DOCKET	
09-AFC-2	
DATE	<u>OCT 14 2009</u>
RECD	<u>OCT 14 2009</u>

Re: TID Almond 2 Power Plant Project (09-AFC-2) CURE Data
Requests, Set One (Nos. 1 - 106)

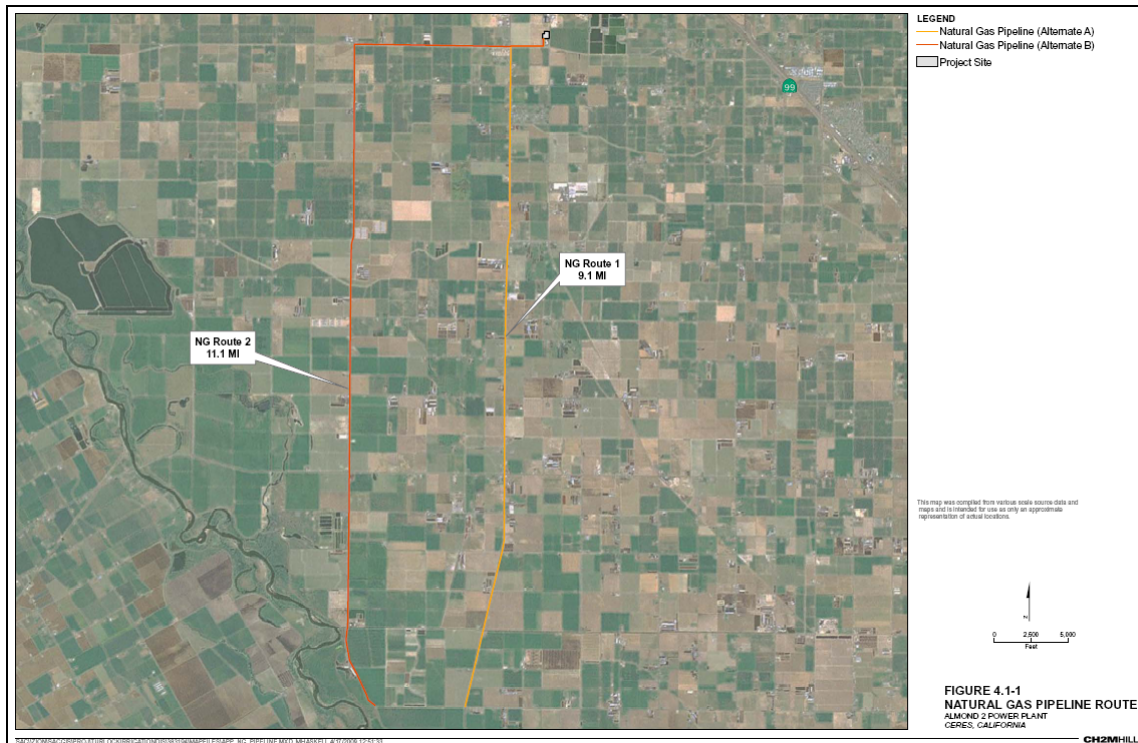
Neither of the natural gas pipeline alternate routes are evaluated in the ESA. The Phase I ESA report does not refer to the location of the proposed natural gas pipeline or the electricity transmission line. The excavations for the natural gas pipeline are proposed to be to a depth of 54 inches.³²

Soil sampling is necessary in order to ensure that the health of construction workers is not put at risk. In response to CEC Data Request Number 77, the applicant is planning to conduct a Phase I ESA for the proposed routes.³³ However, such an investigation will not include soil testing for the potential presence of residual pesticides in soil.
